ADDENDUM No. 5

Date: February 13, 2026

Project: 221 State Street Building Renovations
Augusta, Maine

1 ENLARGED FIRST FLOOR LOCKER ROOM PLANS
 AE102/AE441 SCALE: 1/4"=1'-0"

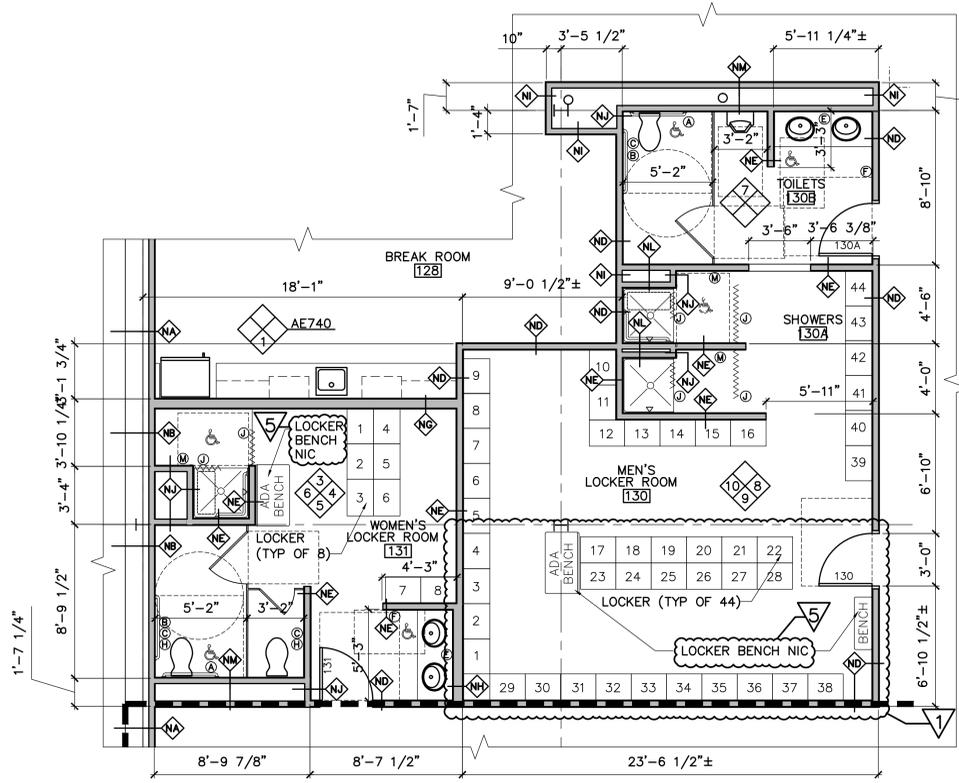
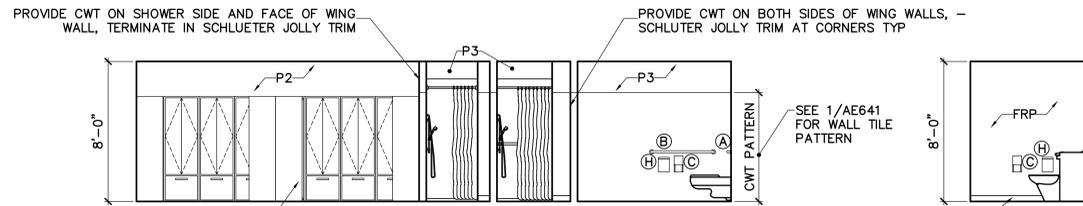
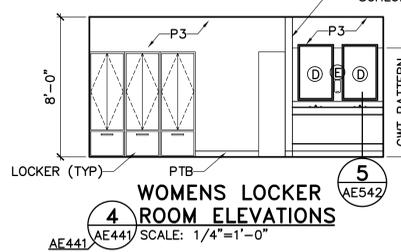
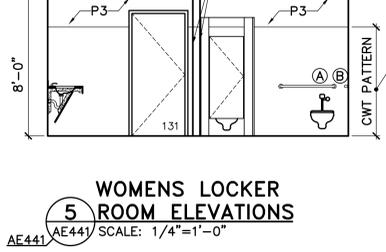
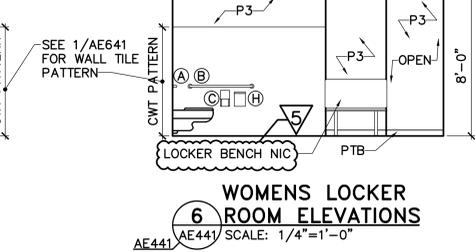
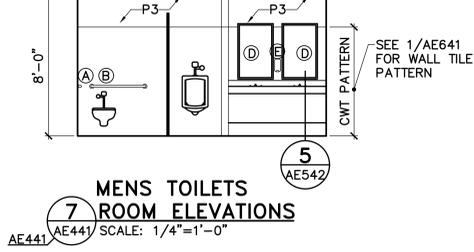
8. Sheet AE441:
 - a. **REVISE SHEET**: INCLUDED IN THIS ADDENDUM
 - b. Locker room benches are not in contract. They will be purchased through an FF&E package. See details 1/AE441, 6/AE441 and 8/AE441.

B. Paragraph 2.6 LOCKER BENCHES: **DELETE** Locker Benches paragraph in its entirety.

1 ENLARGED SECOND FLOOR TOILET ROOM PLANS
 AE103/AE442 SCALE: 1/4"=1'-0"

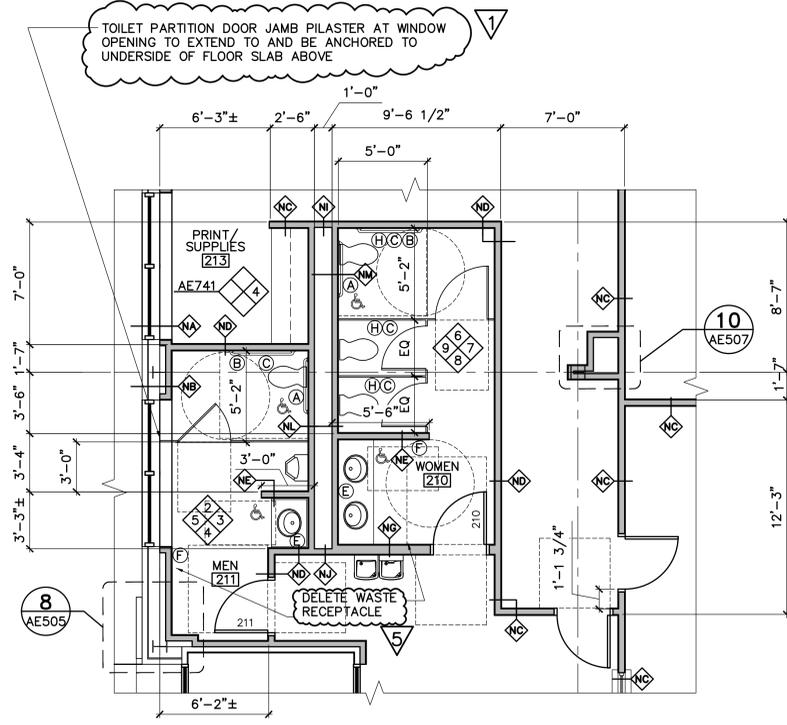
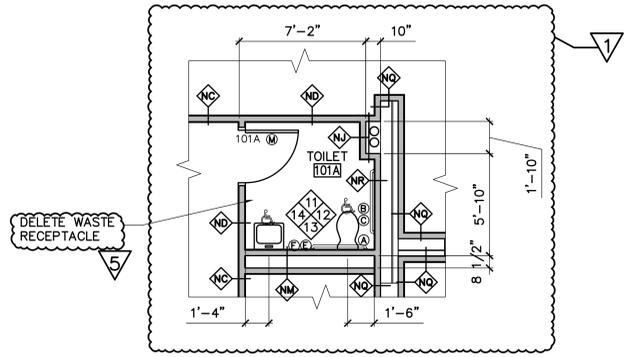
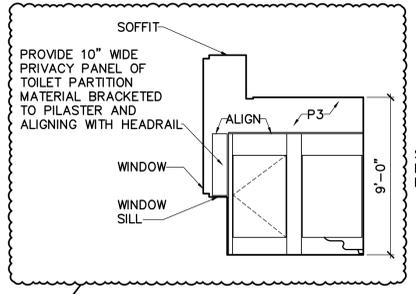
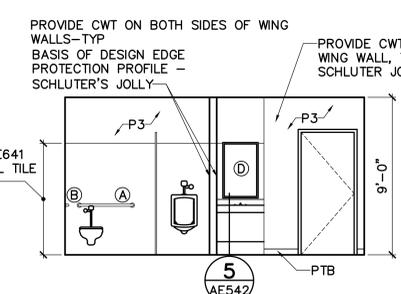
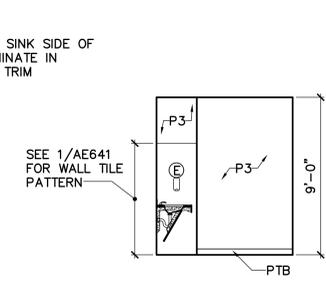
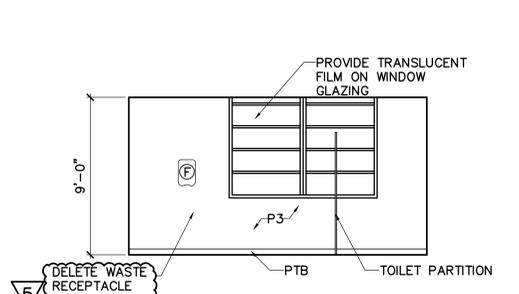
9. Sheet AE442:
 - a. **REVISE SHEET**: INCLUDED IN THIS ADDENDUM
 - b. Remove waste receptacle in rooms 101A, 210 and 211. See details 1/AE442, 5/AE442 and 10/AE442.

1 DIRECT DIGITAL CONTROL SYSTEM ARCHITECTURE
M-701 SCALE: NOT TO SCALE

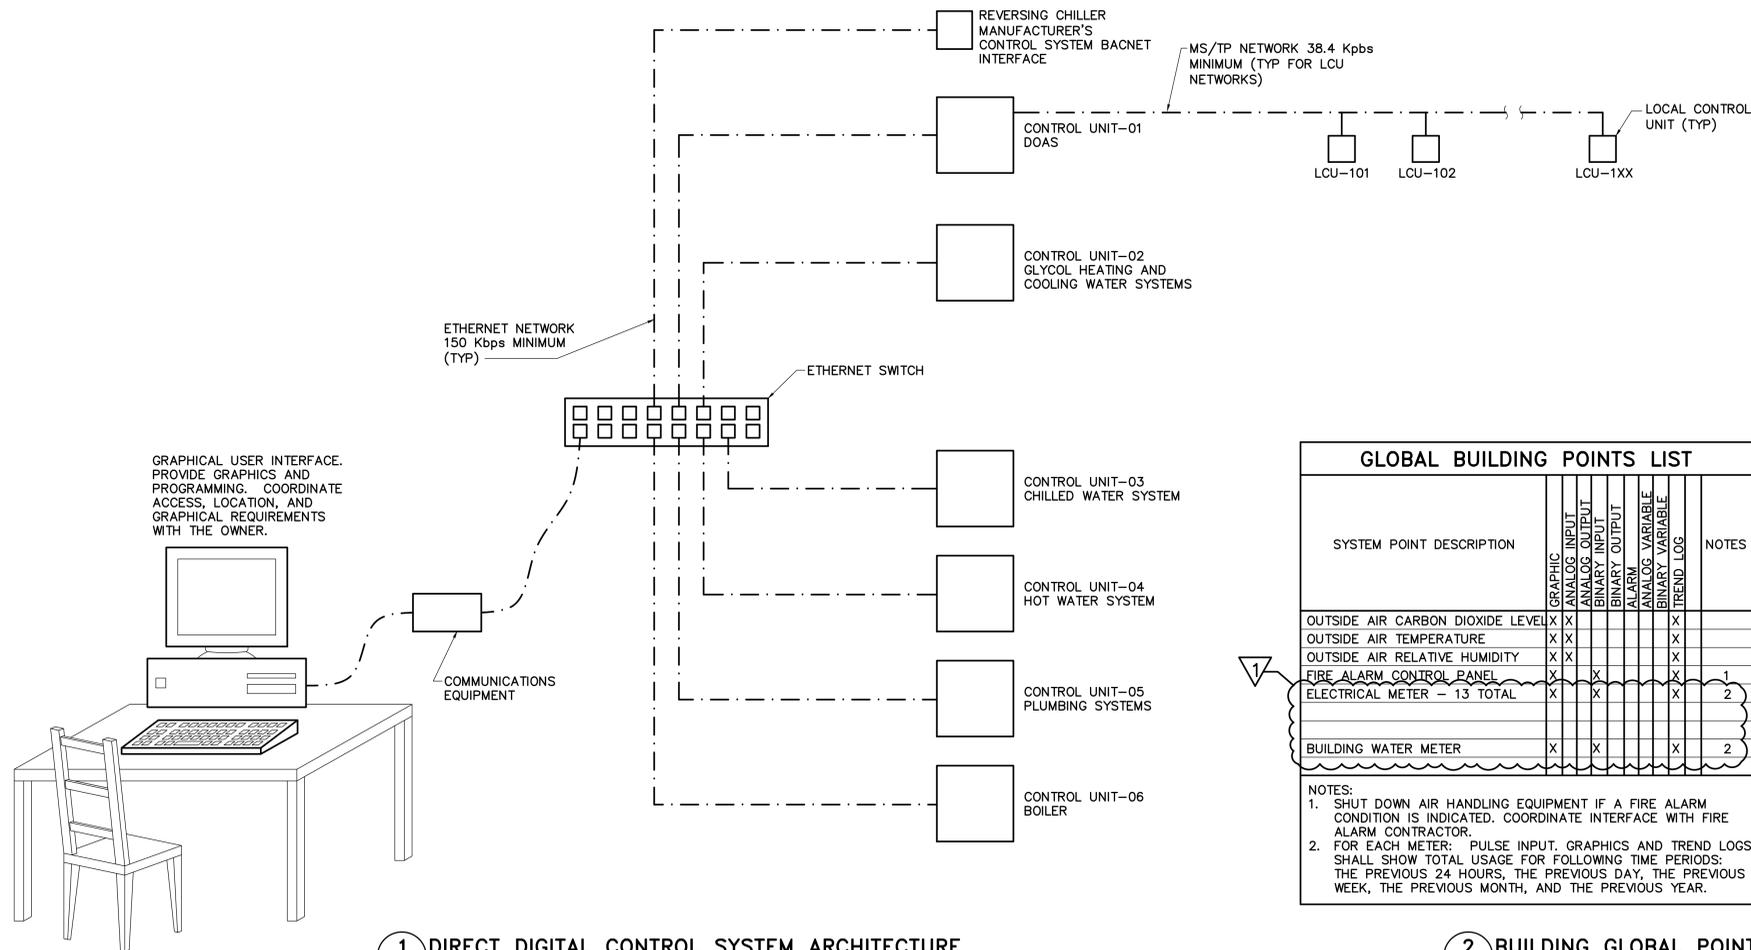
- b. Control Valve Schedule:
 - i. **CHANGE** Chilled Water Supply Valve GPM to "88.9", and Hot Water Supply Valve GPM to "131.6".
 - ii. **CHANGE** DOAS Heating Coil Valve flow rate to 58 gpm.

- iii. **ADD** FCU Cooling Coil Valve (2-way) and FCU Heating Coil Valve (2-way) quantities of "55".
 - iv. **CHANGE** FCU Cooling Coil Valve (3-way) and FCU Heating Coil Valve (3-way) quantities to "11".

- v. **REVISE** FCU Cooling Coil Valve (3-way) and FCU Heating Coil Valve (3-way) list of equipment served.
 - vi. **REVISE** CAV Reheat Coil list of equipment served.

- vii. **ADD** Panel Radiator quantity of "6".
 - viii. **CHANGE** Cabinet Unit Heater quantity to "5".
 - ix. **ADD** Line for Cabinet Unit Heater (3-way) to schedule.

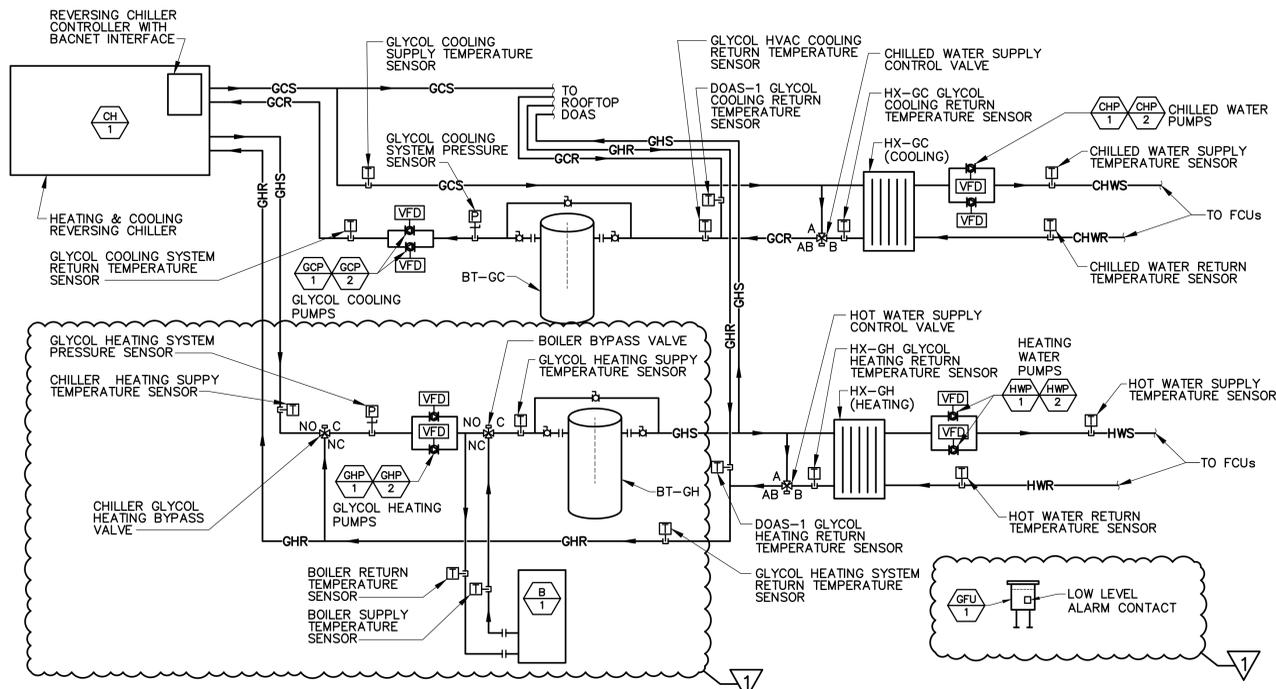
6. Sheet M-702:
 - a. **REVISE SHEET: INCLUDED IN THIS ADDENDUM.**
 - b. Heating and Cooling Water Control Diagram 1/M-702: In the Points List, **CHANGE** Boiler Bypass Valve from a Binary Output to an Analog Output for valve modulation control.

- c. Heating and Cooling Water Control Diagram 1/M-702: **CHANGE** Sequence of Operations as highlighted on attached drawing.
